# Groundwater Transfer Review Summary Form

Transfer/PA # T- 14663

Application: T-14663

Applicant Name: DNJ, LLC

Theis Drawdown and Recovery at BENT 55423 from pumping at APOA, BENT 55321

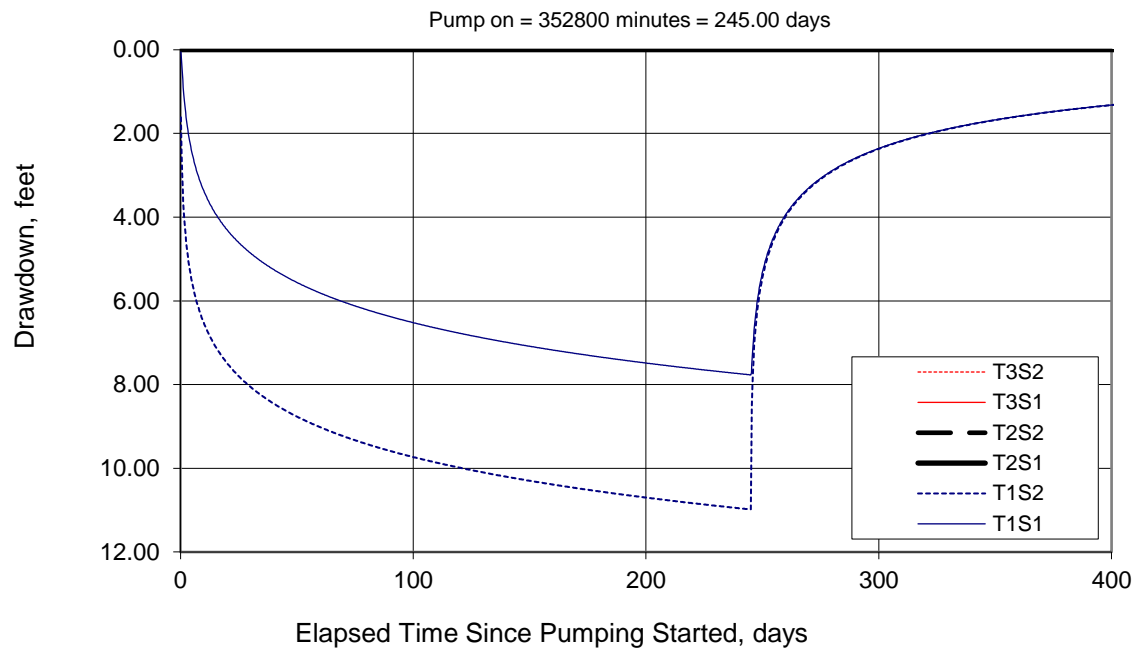
- b) If yes, would this proposed change, at its maximum allowed rate of use, likely result in another groundwater right not receiving the water to which it is legally entitled?  
☐ Yes ☒ No If yes, explain: Potential interference with BENT 2544 and BENT 55432 from the proposed changes were evaluated using the Theis (1935) solution for drawdown in a confined aquifer (see attached Well Interference Analyses). The results indicate that the proposed changes are unlikely to injure neighboring groundwater rights.

Radial distance,  $r = 1150$  ft [approximate distance from APOA, BENT 55321 to BENT 55423]

Pumping time,  $t_{\text{pump}} = 245$  days [irrigation season]

Pumping rate,  $Q = 0.38$  cfs [max rate under Certificate 5028]

Transmissivity:  $T1 = 1.870$  ft<sup>2</sup>/day [pumping test report BENT 980]

Storativity:  $S1 = 0.003$ ;  $S2 = 0.0003$  [Conlon et al., 2005]

Theis Drawdown and Recovery at BENT 2544 from pumping at APOA, BENT 55224

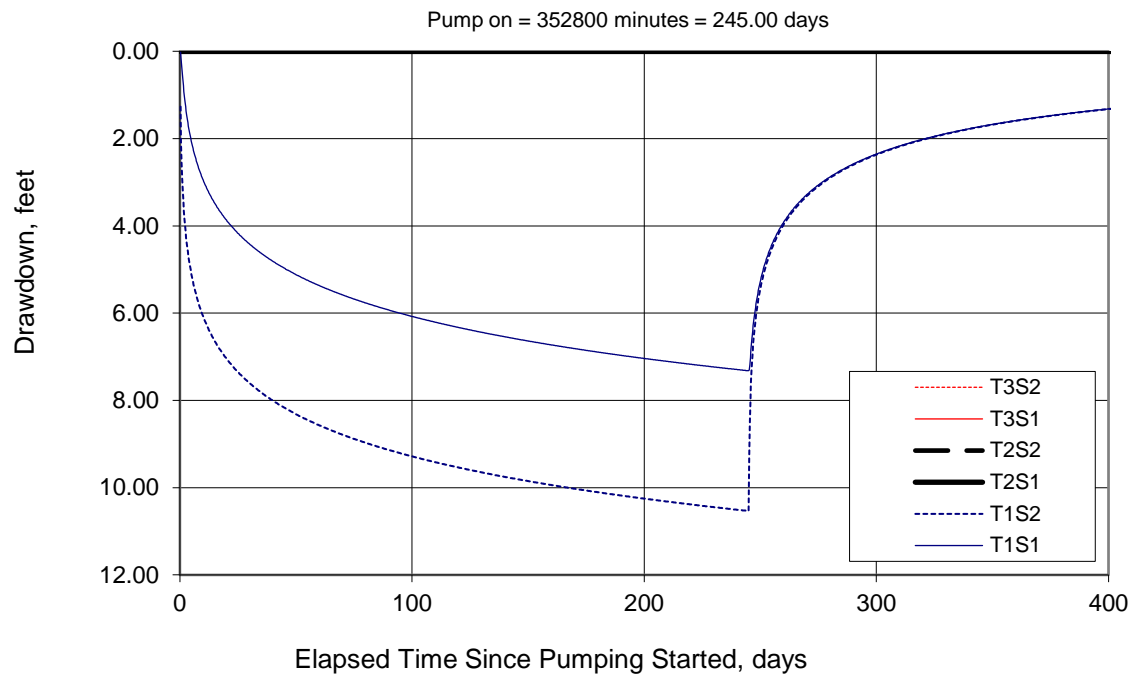
Radial distance,  $r = 1,350$  ft [approximate distance from APOA, BENT 55224 to BENT 2544]

Pumping time,  $t_{\text{pump}} = 245$  days [irrigation season]

Pumping rate,  $Q = 0.38$  cfs [max rate under Certificate 5028]

Transmissivity:  $T1 = 1.870$  ft<sup>2</sup>/day [pumping test report BENT 980]

Storativity:  $S1 = 0.003$ ;  $S2 = 0.0003$  [Conlon et al., 2005]
